Access Compliance Report Public Rights-of-Way (Curb Ramps)

Main Street: SANTA_ANA_AVE Cross Street: MESA_DR Location: SE

ADA ID: RPAT220128174225 Ramp Type: Type 1 - Perpendicular Diagonal Initial Pass/Fail: Pass Overall Compliance: No Severity Score: 0

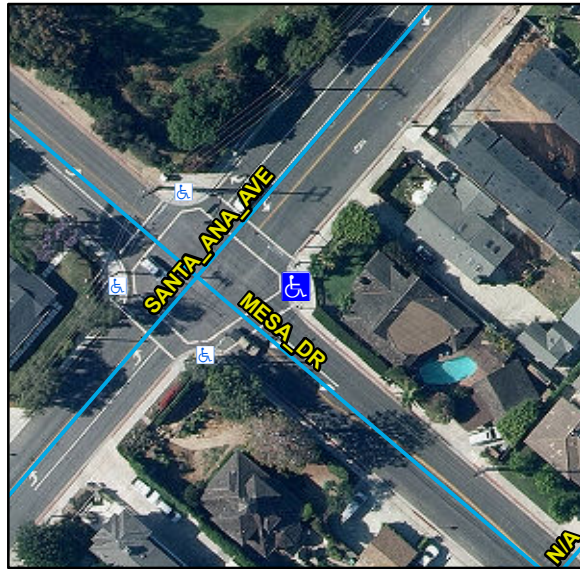
Remove & Replace Curb Slope. Utility Present.

R304.2.2, STD 1115

Yes	Ramp Inside Crosswalk 1	Yes	Yes	Ramp Inside Crosswalk 2	Yes
	Crossing 1 Slope (%)	7.7		Crossing 2 Slope (%)	5
	Crossing 1 Cross Slope (%)	0.3		Crossing 2 Cross Slope (%)	0.3
Yes	Gutter Ponding	No	No	Curb Slope	6.6
Yes	Gutter Lip Height (in)	0		Road Run Slope (%)	1.6
Yes	Gutter Run Slope (%)	3.2		Road Cross Slope (%)	5
Yes	Gutter Cross Slope (%)	0.8			
Yes	Overall Surface Condition: Acceptable		Yes	Perp Joint Present	Yes
	Cross Gutter Present?	No		Spandrel Present?	No
	Replace Cross Gutter?	N/A		Replace Spandrel?	N/A
